PROJECT
SITE
IMPROVEMENTS
TO LAWRENCE
CENTRAL HIGH
SCHOOL AND
RELATED
WORK

LAWRENCE CENTRAL HIGH SCHOOL
MSD LAWRENCE TOWNSHIP
INDIANAPOLIS, INDIANA

QILINTA GENERAL CONTRACTORS, INC. DOCUMENT REFERENCE STATUS:	SPEC. SECTION: ASBURY
☐ REVIEWED ☐ APPROVED AS NOTED ☐ REJECTED	DATE: 2/20/00 BY: ASBURY

DRIVEWAY CHANGES,
SCOREBOARD, AND SOCCER GOALS

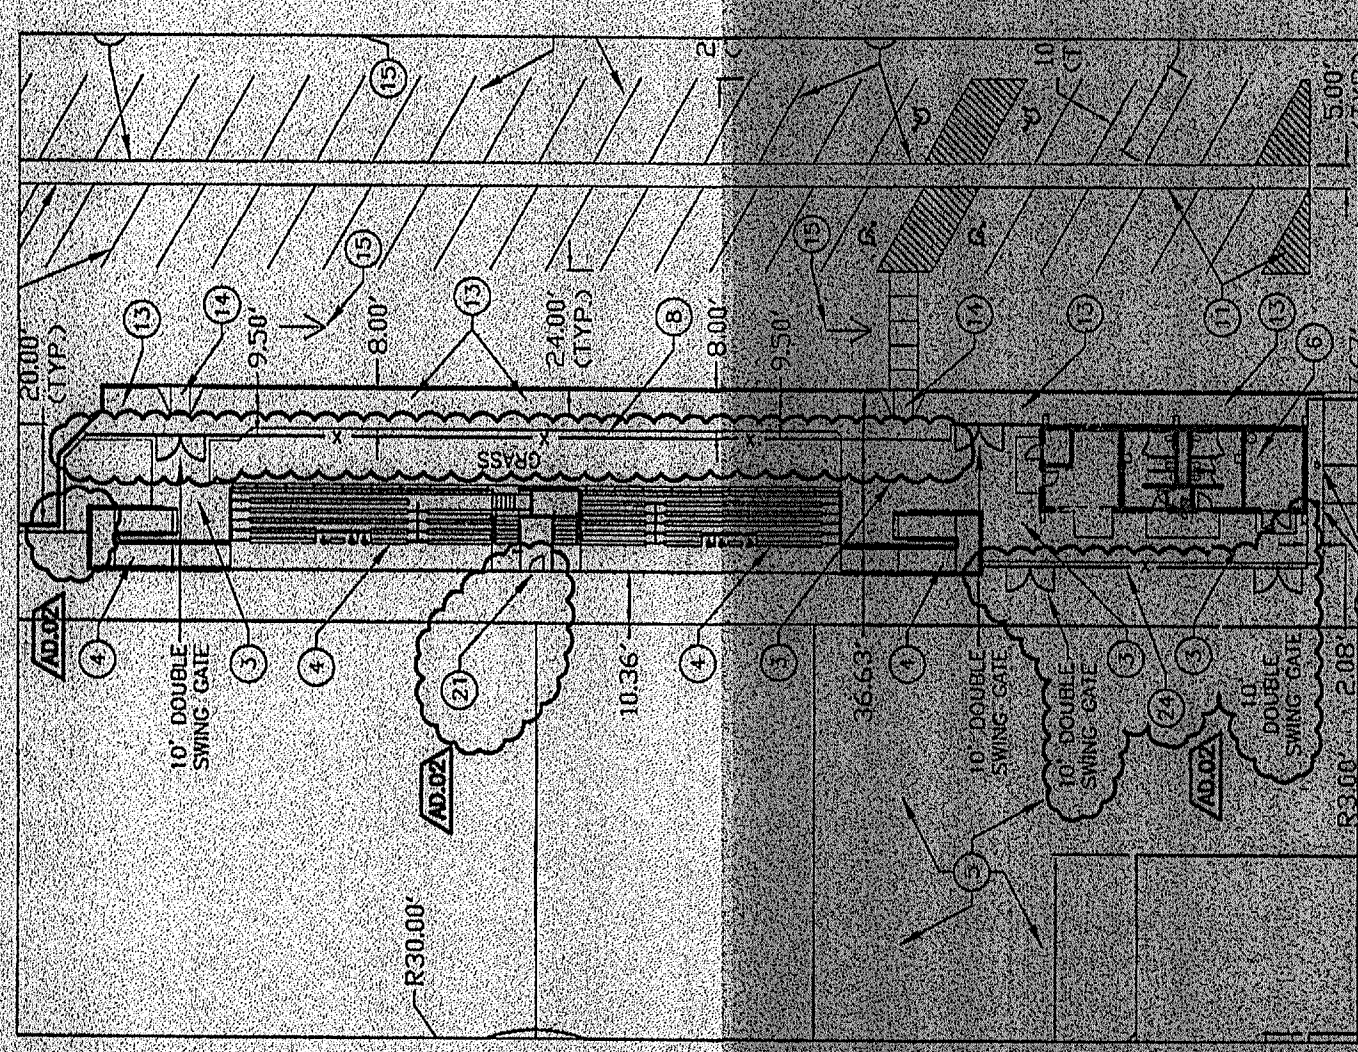
17. Having contractor install gravel drive. See Detail. (Alternate work: install asphalt driveway and gravel drive)
18. ALTERNATE WORK: INSTALL 85' OF GUARDRAIL. SEE DETAIL.

19. **EXISTING GATE MATCH TO FENCE HEIGHT. PROVIDE SLIDING GATE MECHANISM FOR SLIDING GATE.**
20. INSTALL KEY ACCESS MECHANISM FOR SLIDING GATE.

DRAWING
CIVIL UTILITY PLAN

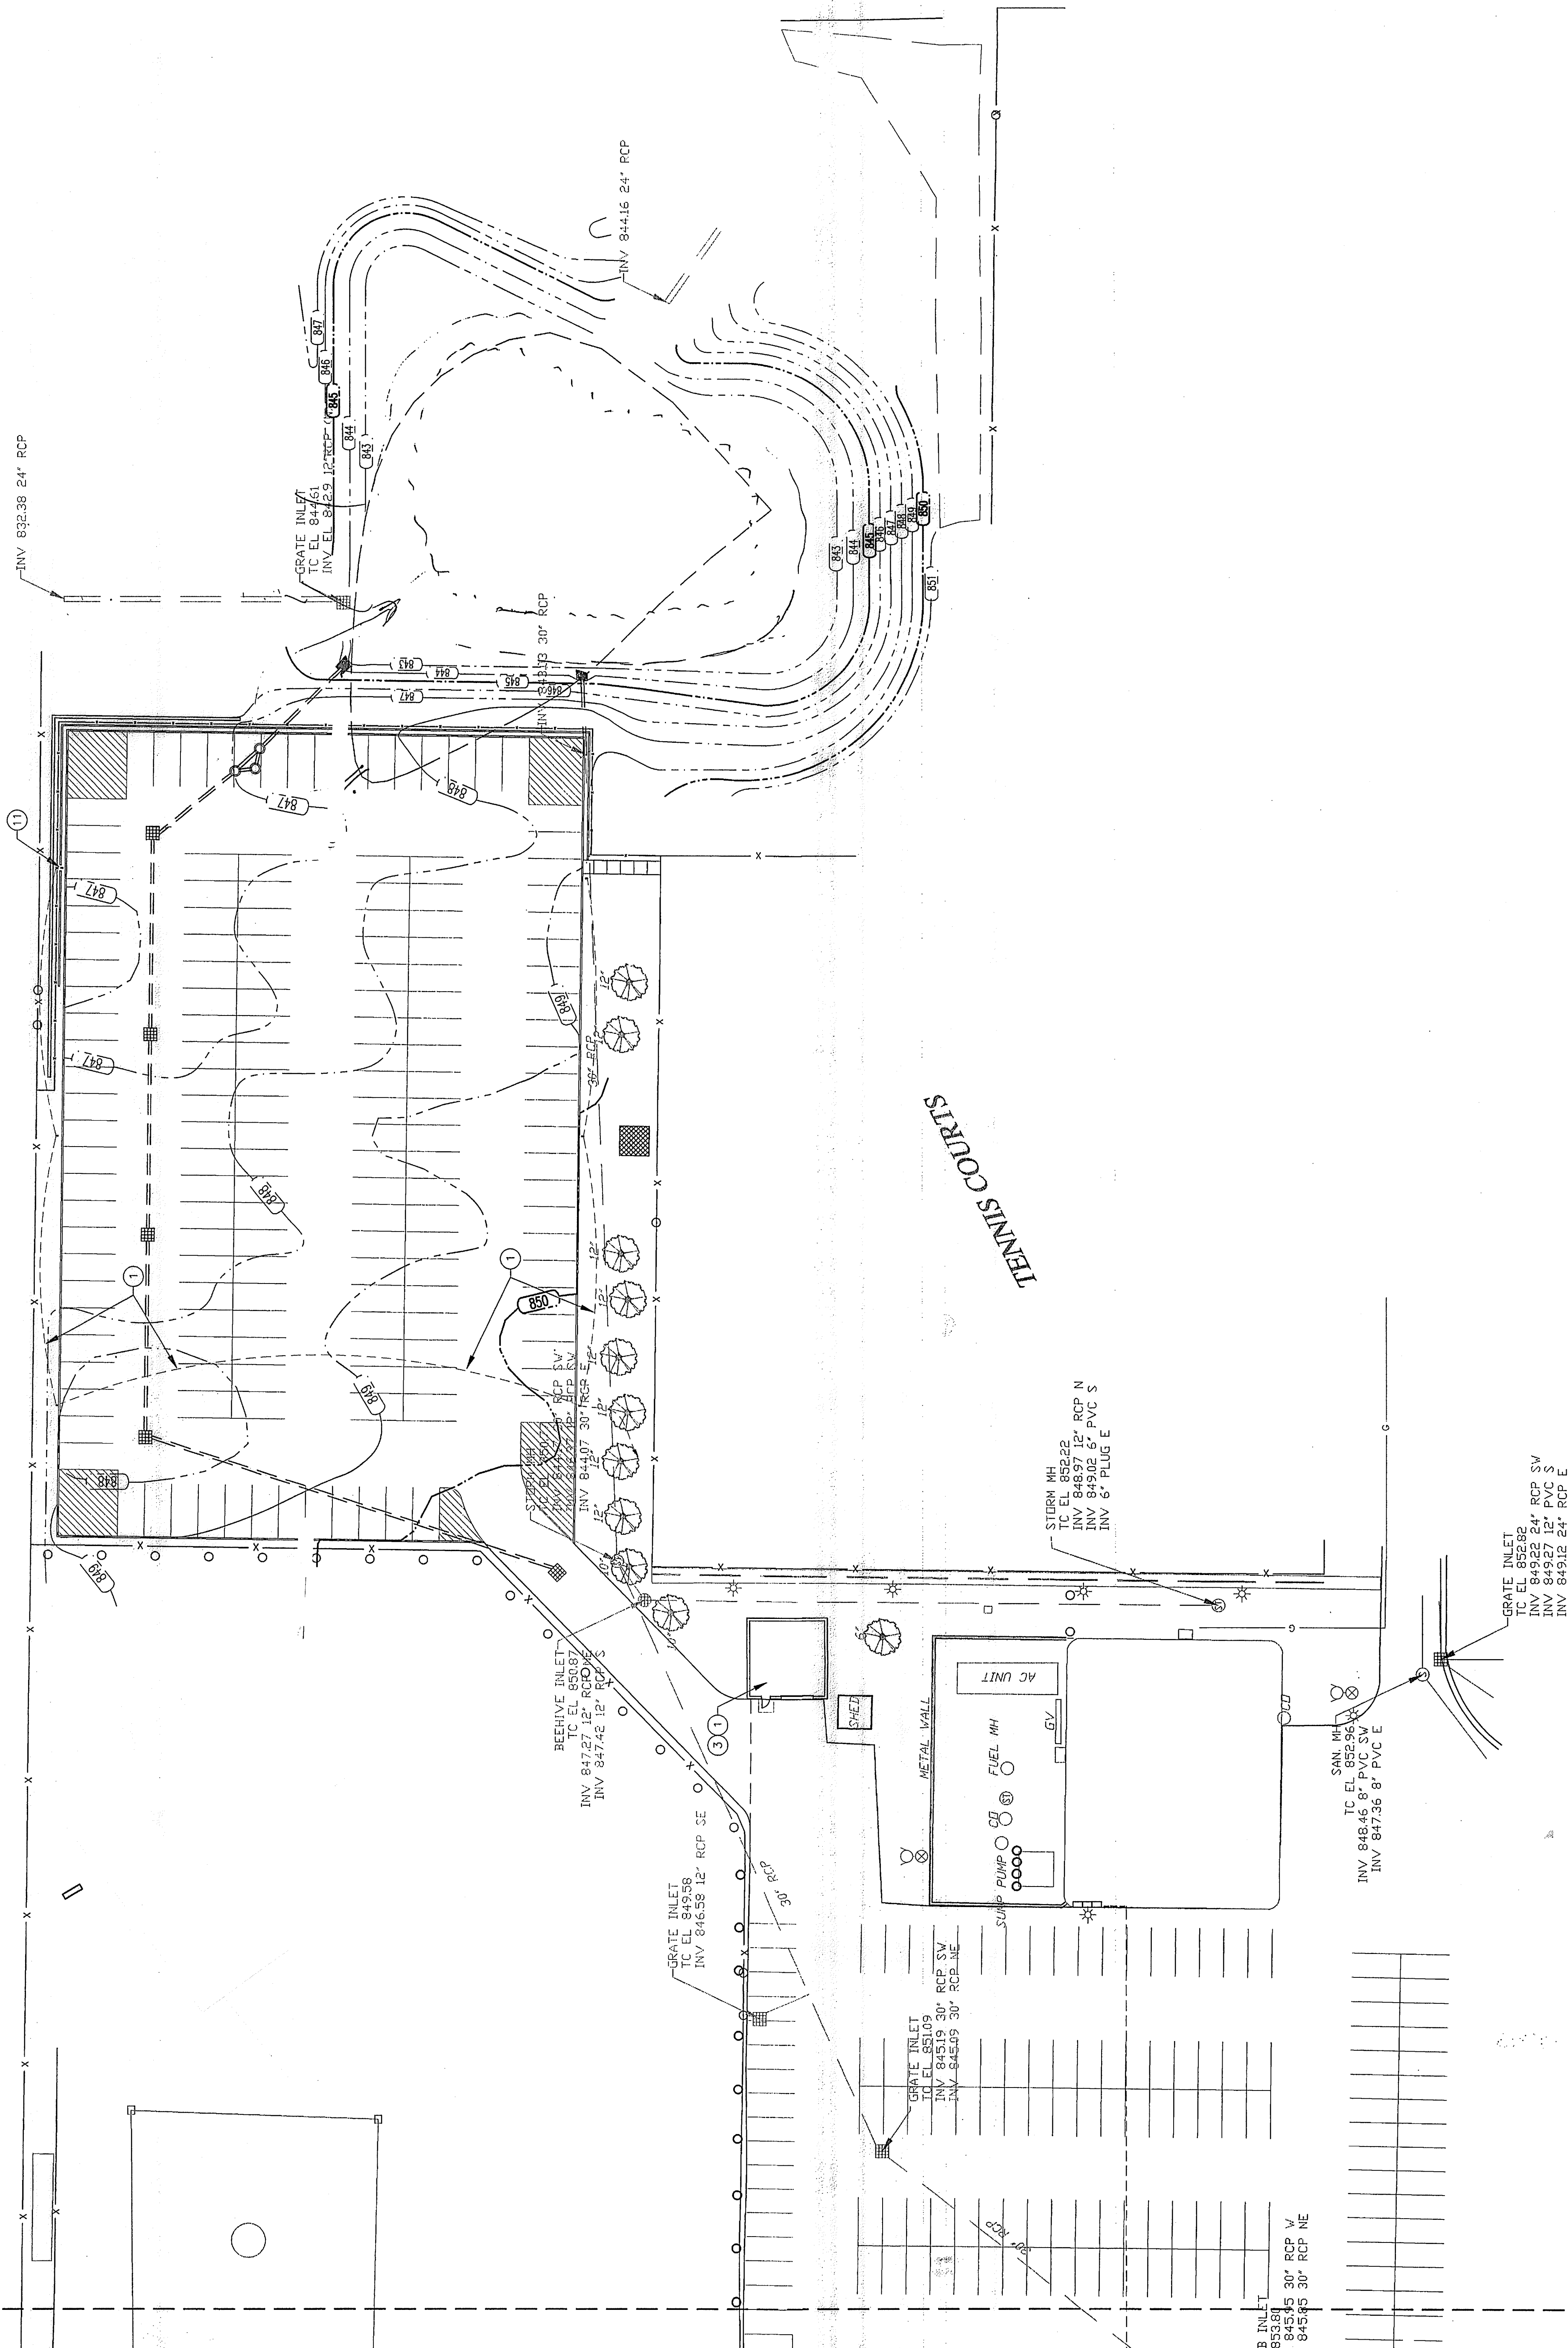
11. Light pole and base interrupt guardrail. See electrical drawings for actual layout and verify space needed for light pole with electrical contractor."

SEWAGE EJECTOR DETAIL

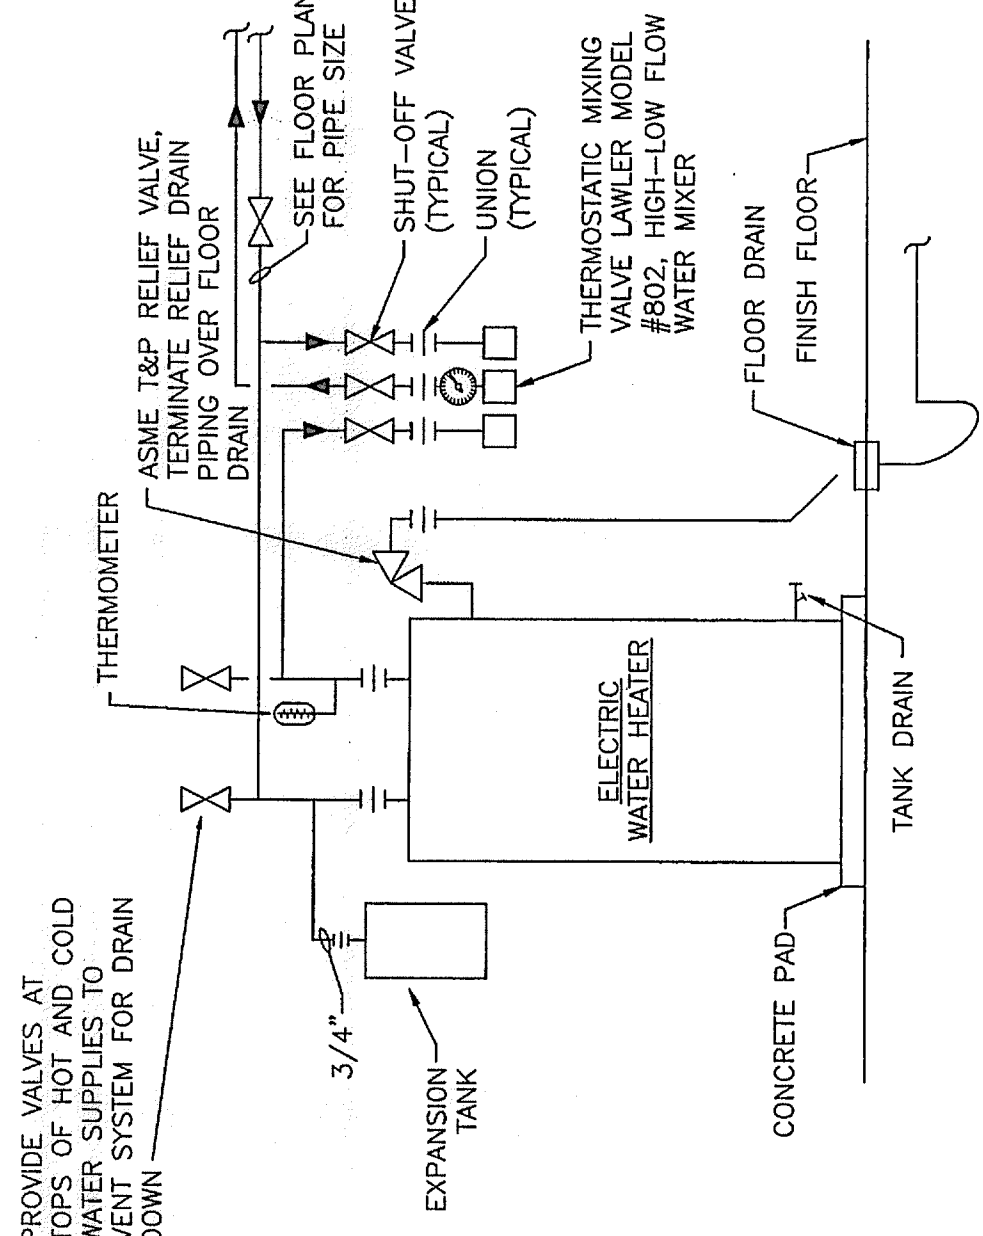
A. Sewage ejector pit shall be 8'-0" deep X 48" in diameter. Delete references on Detail to 60" deep and 8'-4" deep.
